Sub:- Proposal for diversion of 130.062 ha forest land for construction of 132 KV transmission line from Khupi to Seppa under Comprehensive Scheme for strengthening of transmission and distribution system in East & West Kameng District of Arunachal Pradesh – reg.

**Sub: Submission of compliance report for diversion of 130.062 ha of forest land for laying of 132 kV Khupi- Seppa TL under Comprehensive Scheme for strengthening of T&D in AP.**

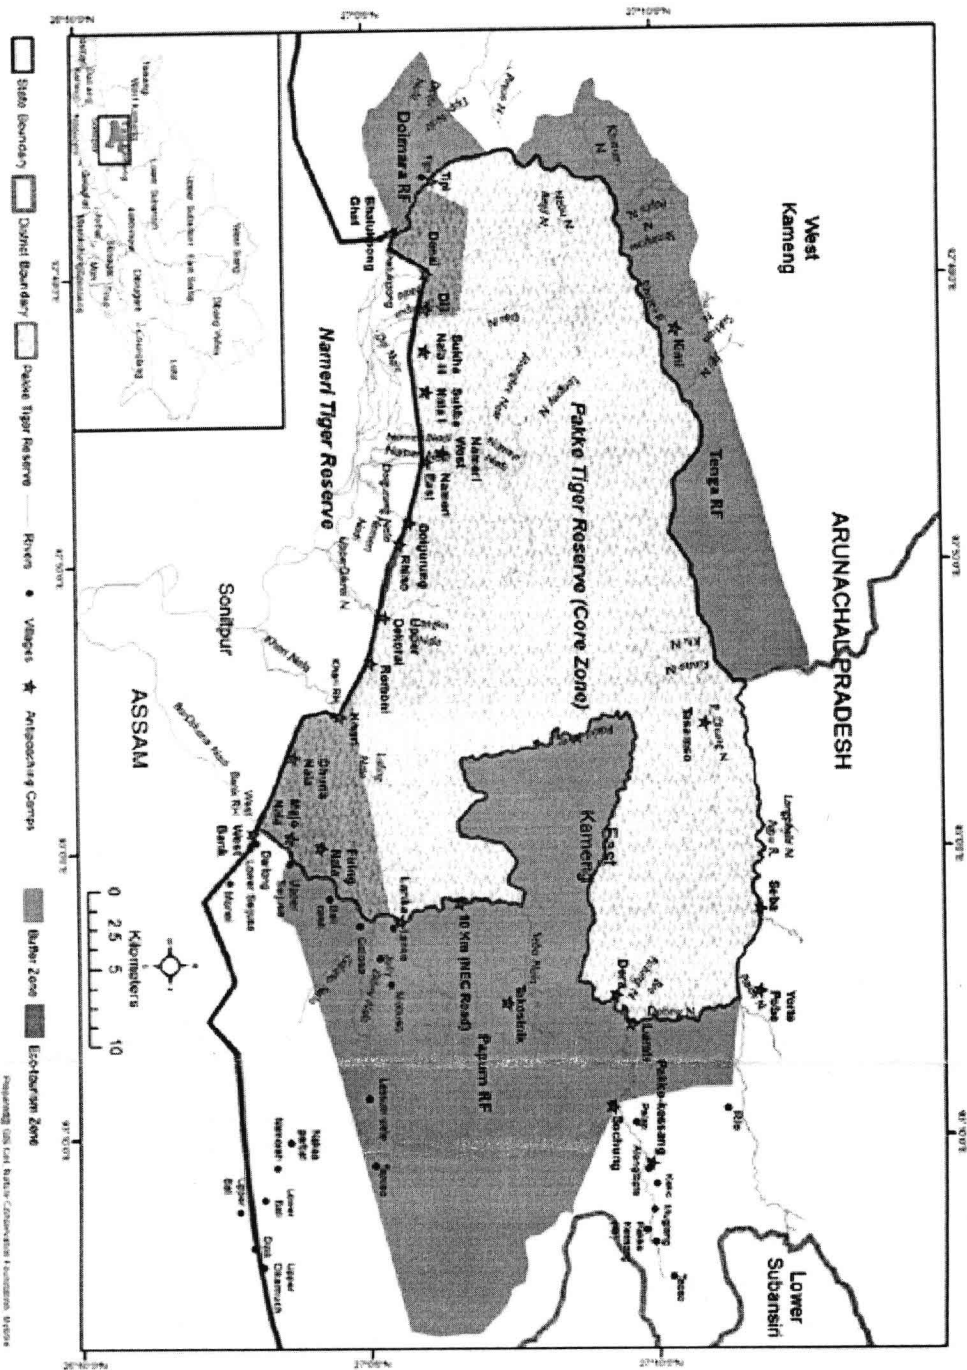
Sl.No.	Query	Compliance
1	The Shape file of the Proposed area is found to be Inviolatue due to presence of Pakke Tiger Reserve.	<p>The boundary of the Pakke TR (kml file) has been obtained from the NTCA website. Also the notification of Pakke TR (buffer zone) and map has been analyzed in ARC-GIS. After careful analysis it has been observed that</p> <ol style="list-style-type: none"> <li>1) the proposed route alignment is more than 5 km from Pakke Tiger Reserve core area (<i>Enclosed Map</i>),</li> <li>2) The proposed route alignment is also outside the Pakke TR (buffer area) (<i>Enclosed map</i>)</li> </ol> <p>As per the guideline of MoEF (<i>OM enclosed</i>), projects falling in the ESZ but not requiring Environmental Clearance will also not require approval of NBWL. Transmission lines being exempted from EC clearance, hence do not require Wildlife clearance if falls within the ESZ.</p>
